Golder Associates Inc.

July 21, 2003

RE: UNITED STATES SUGAR CORPORATION (U.S. SUGAR) – CLEWISTON MILL
PROPOSED NEW BOILER NO. 8
DEP PROJECT NO. 0510003-021-AC (PSD-FL-333)
ADDITIONAL INFORMATION RESPONSE #3

Facility Plot Plan
U.S. Sugar – Boiler No. 8

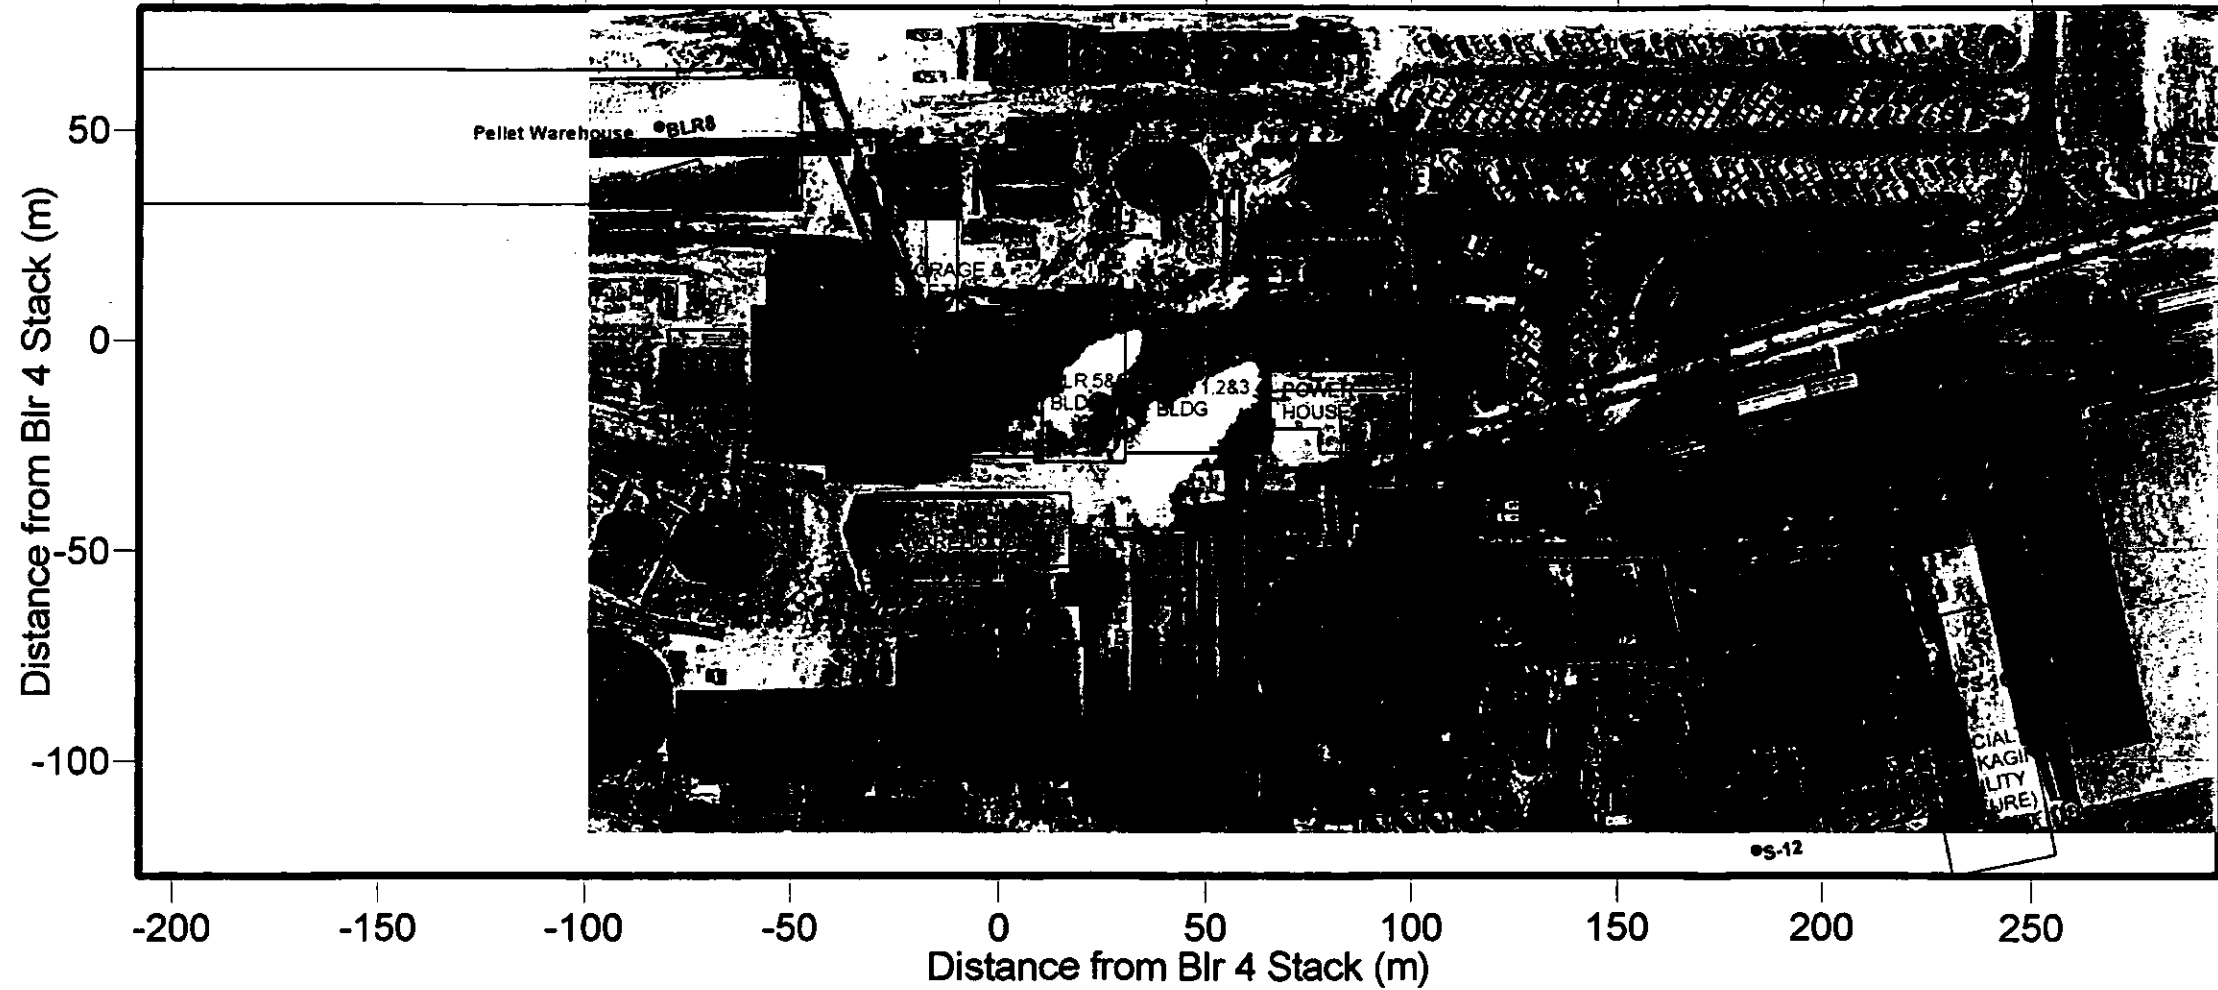
1. The building information contained in the facility plot plan Attachment UC-FI-C2, Page 3 and the BPIP building, structure data and location data contained in the figures and information in Appendix K do not appear to match. Please indicate which of these is correct. In addition, please update the application with the correct, detailed building structure information used in the modeling to determine downwash impacts. This information should include building dimensions for all buildings used in the modeling analyses. In addition, please provide a detailed plot plan to scale of the facility showing the exact location of the modeling origin in meters and the location from this modeling origin of each building and stack. All stacks and buildings should be labeled. In addition, a grid with 50 meter spacing should be overlaid over this plot plan so that the information on the plot plan can be easily correlated with the information in the BPIP files.

A. Attached is the requested drawings. Building data from the BPIP file were overlaid on an aerial of the mill. These BPIP data were used in previous air modeling analyses for the mill. As shown in the figure, the buildings used in the model are generally aligned with those shown in the aerial. Any differences are expected to produce minimal, if any, differences in predicted concentrations. It should be noted that the pellet warehouse was modeled as it exists, even though the eastern portion of the warehouse will be removed once Boiler No. 8 is constructed. Since the height of the warehouse is relatively low compared to Boiler No. 8's stack, it does not have an effect on building downwash effects for that stack.

Figure C-1. Population and Household Unit Trends in Hendry County

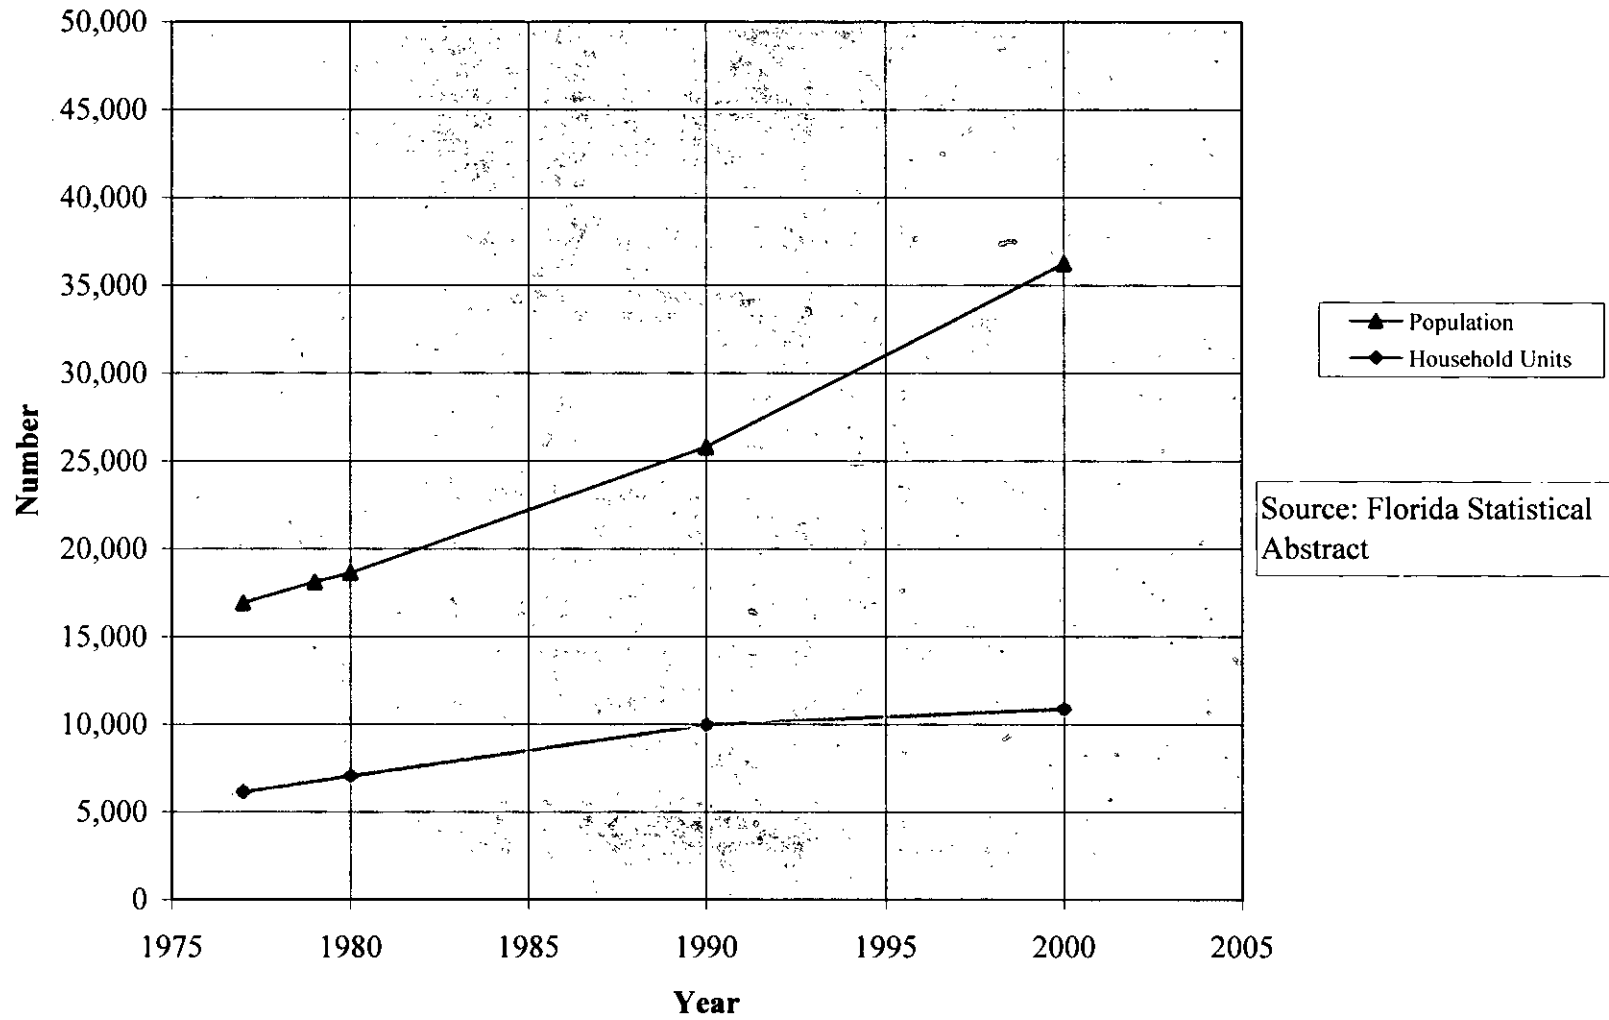
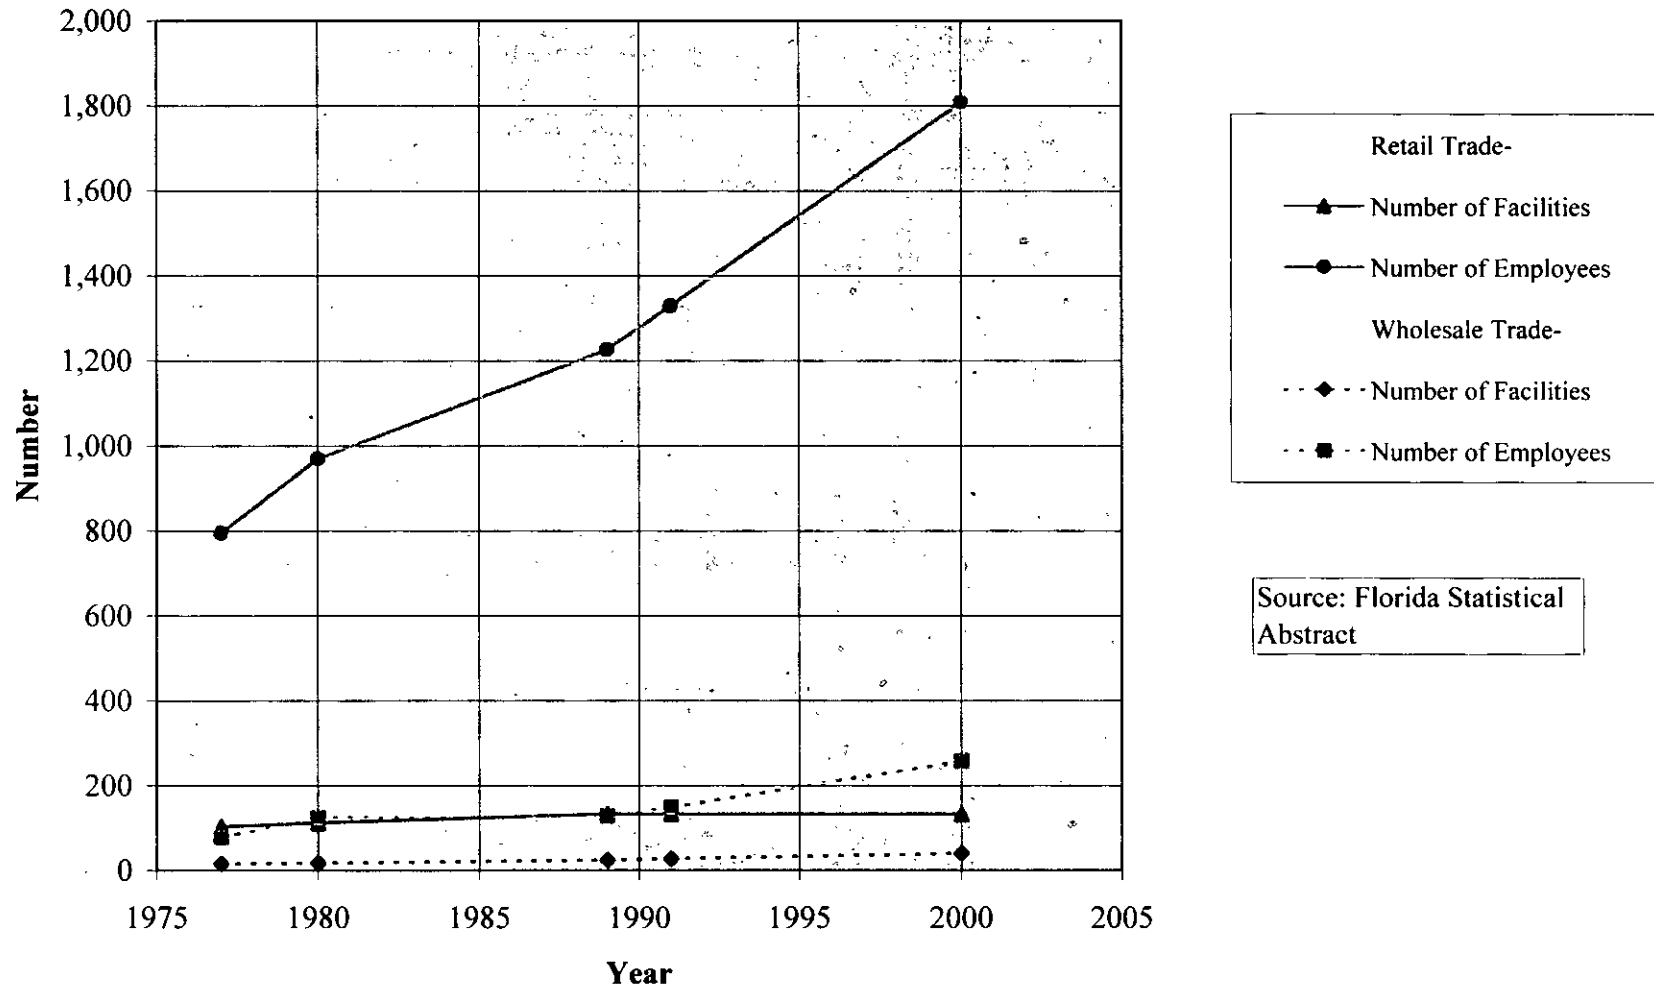
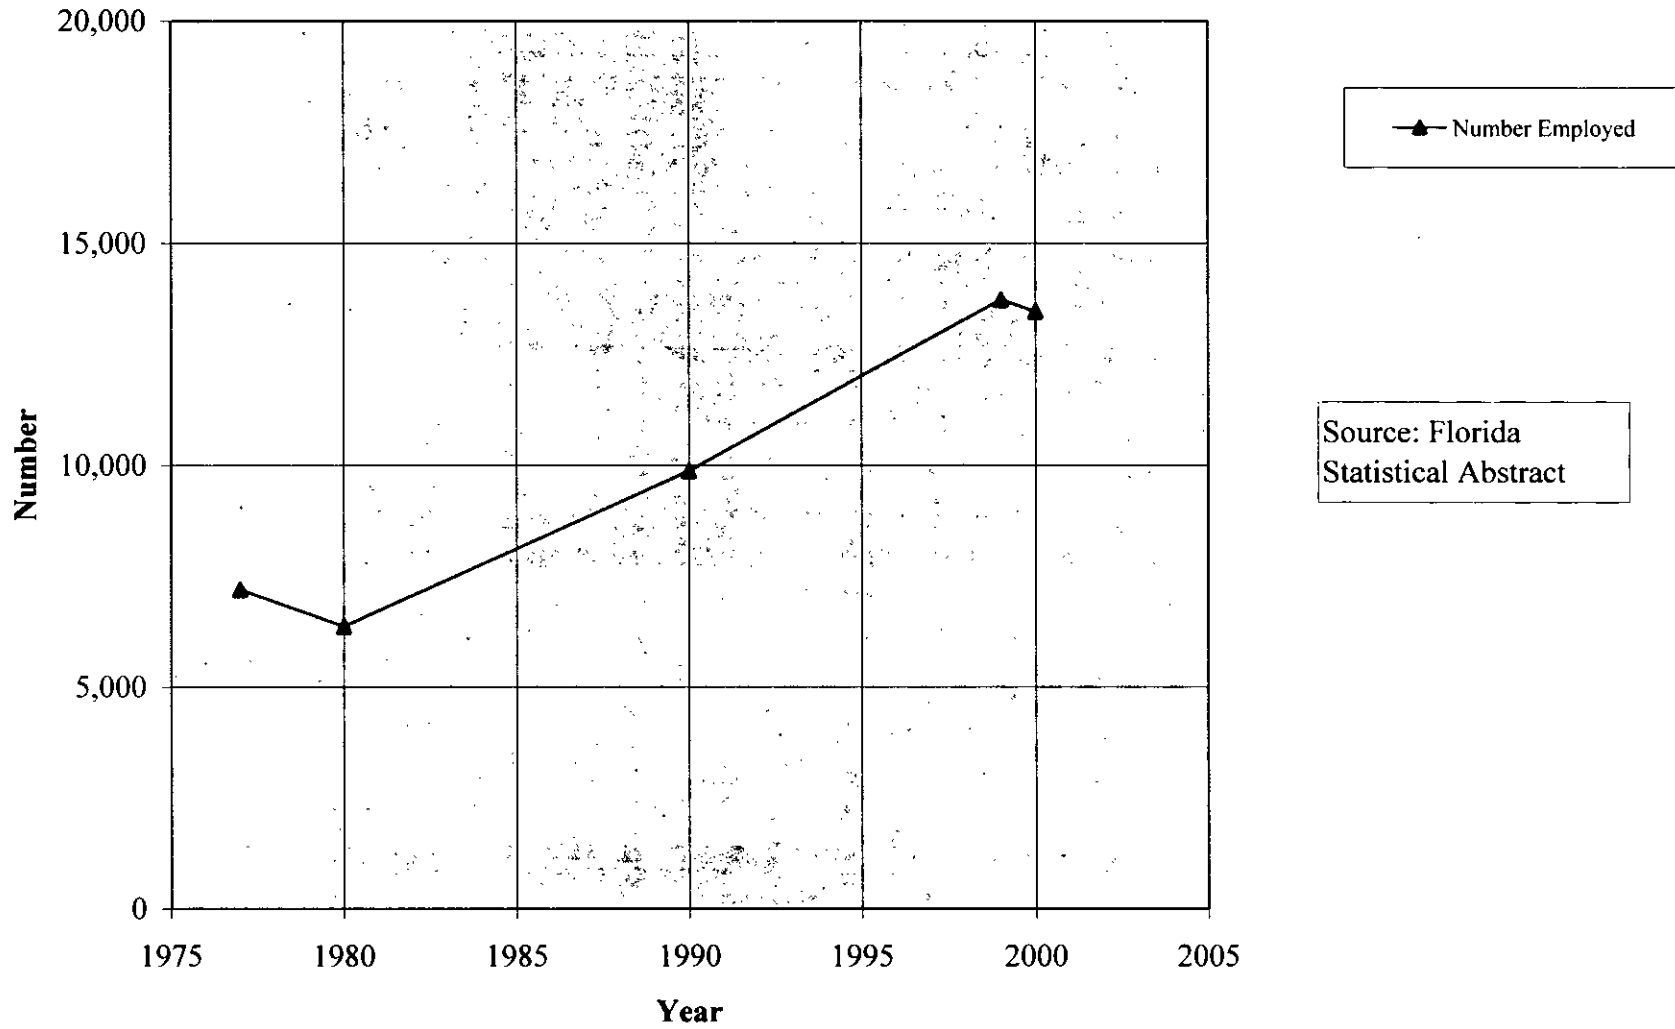
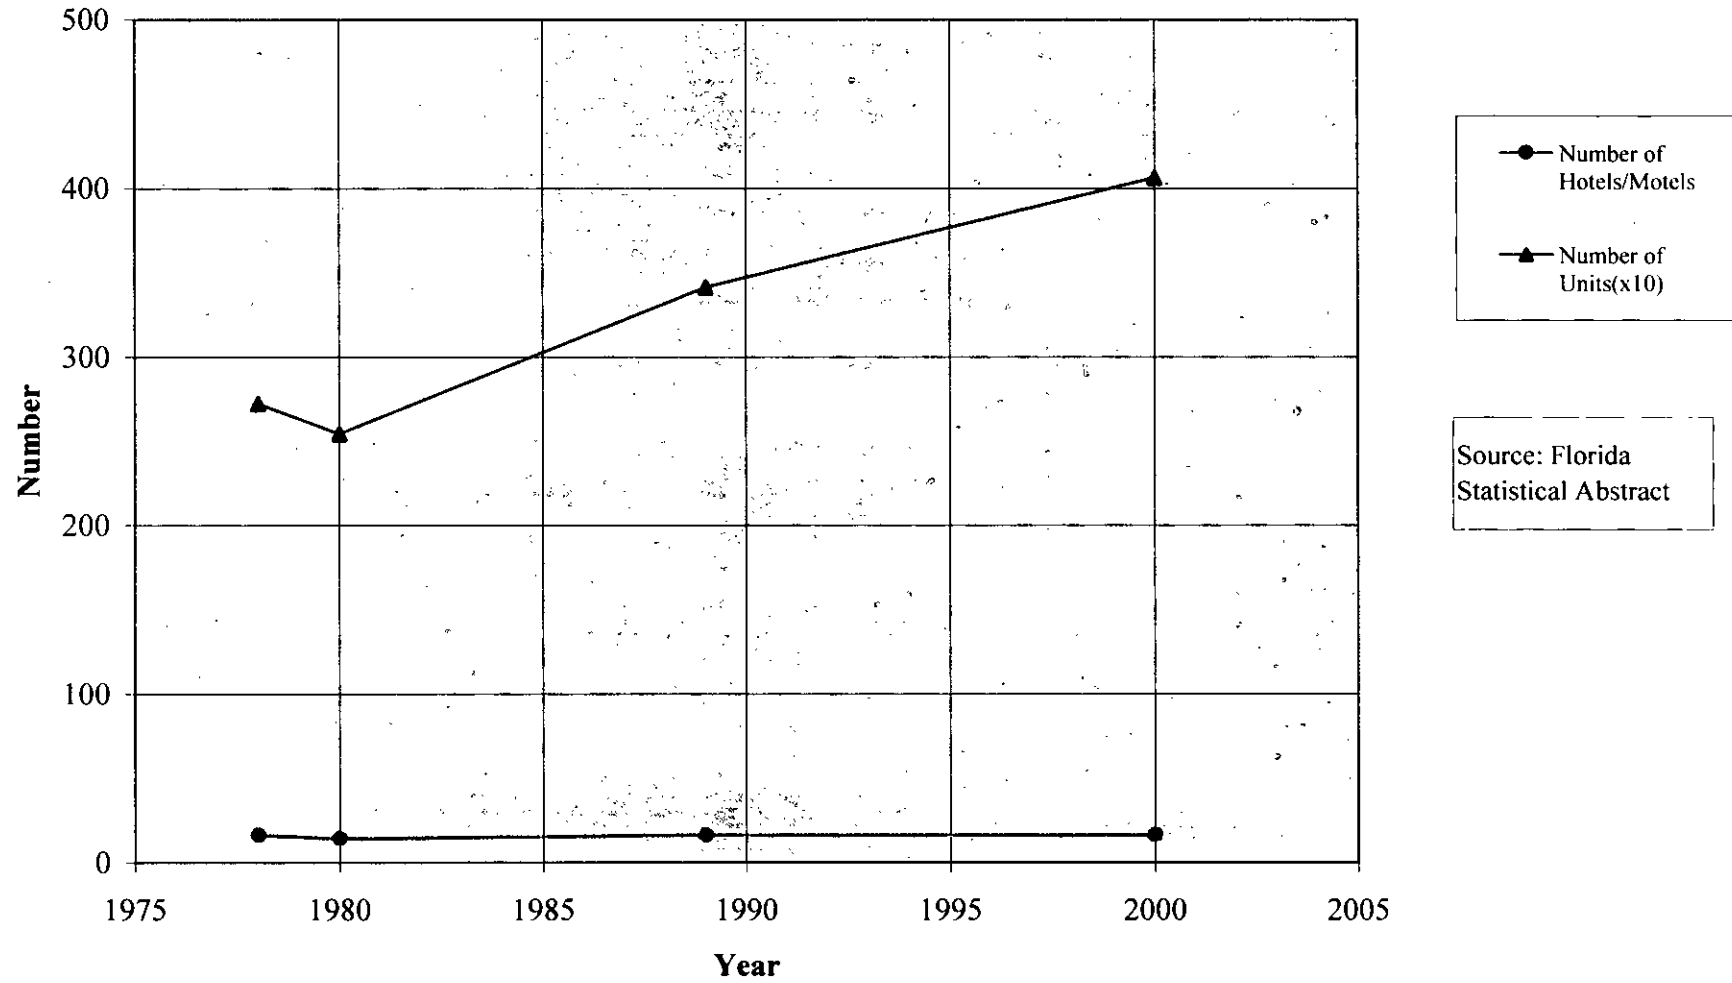
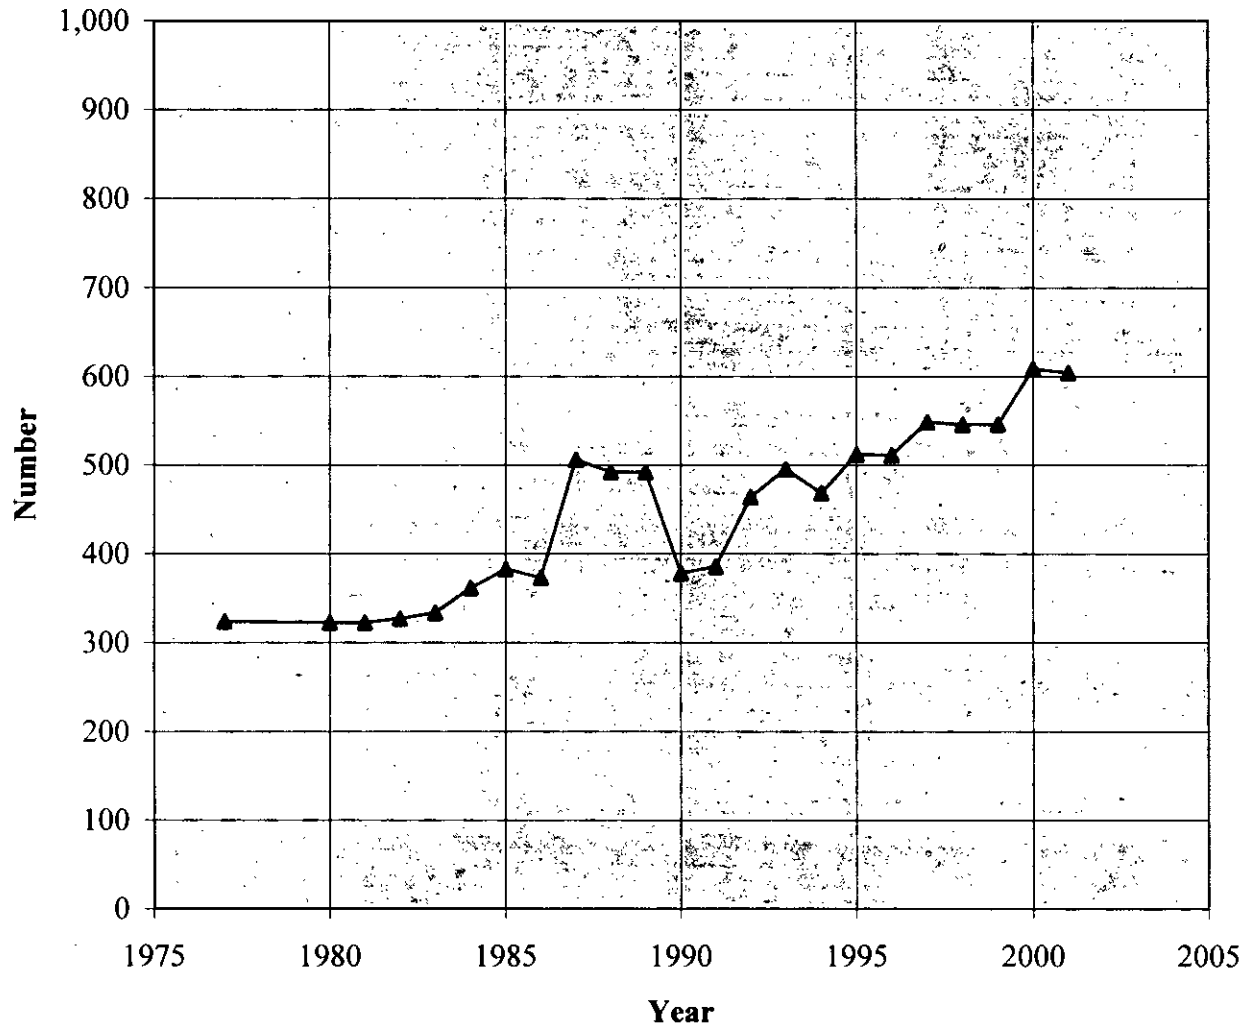
2. Rule 62-212.400(5)(h) 5, F.A.C. requires the applicant to provide information relating to the air quality impact of, and the nature and extent of, all general commercial, residential, industrial and other growth which has occurred since August 7, 1977, in the area the facility or modification would affect. Please provide this information. The additional impacts section 7.0 does not adequately address this requirement.

As an indicator of residential growth, the trend in the population and number of household units in Hendry County since 1977 are shown in Figure C-1. The county experienced a 114 percent increase in population for the years 1977 through 2000. During this period, there was an increase in population of about 19,300. Similarly, the number of households in the county increased by about 4,700 or 77 percent since 1977.

As an indicator of commercial growth in Hendry County, the trends in the number of commercial facilities and employees involved in retail and wholesale trade are presented in Figure C-2. The retail trade sector comprises establishments engaged in retailing merchandise. The retailing process is the final step in the distribution of merchandise. Retailers are, therefore, organized to sell merchandise in small quantities to the general public. The wholesale trade sector comprises establishments engaged in wholesaling merchandise. This sector includes merchant wholesalers who buy and own the goods they sell; manufacturers' sales branches and offices that sell products manufactured domestically by their own company; and agents and brokers who collect a commission or fee for arranging the sale of merchandise owned by others.

The trend in the labor force in Hendry County since 1977 is shown in Figure C-3. The greatest number of persons employed in Hendry County has been in the agriculture, services and government sectors. Between 1977 and 1999, approximately 6,265 persons were added to the available work force, for an increase of 87 percent.

Another indicator of commercial growth in Hendry County is the tourism industry. As an indicator of tourism growth in the county, the trend in the number of hotels and motels and the number of units at the hotels and motels are presented in Figure C-4.

As an indicator of transportation growth, the trend in the number of vehicle miles traveled (VMT) by motor vehicles on major roadways in Hendry County is presented in Figure C-5.

As an indicator of industrial growth, the trend in the number of employees in the manufacturing industry in Hendry County since 1977 is shown in Figure C-6. As shown, the manufacturing industry experienced a moderate increase of 25 percent from 1977 through 1997.
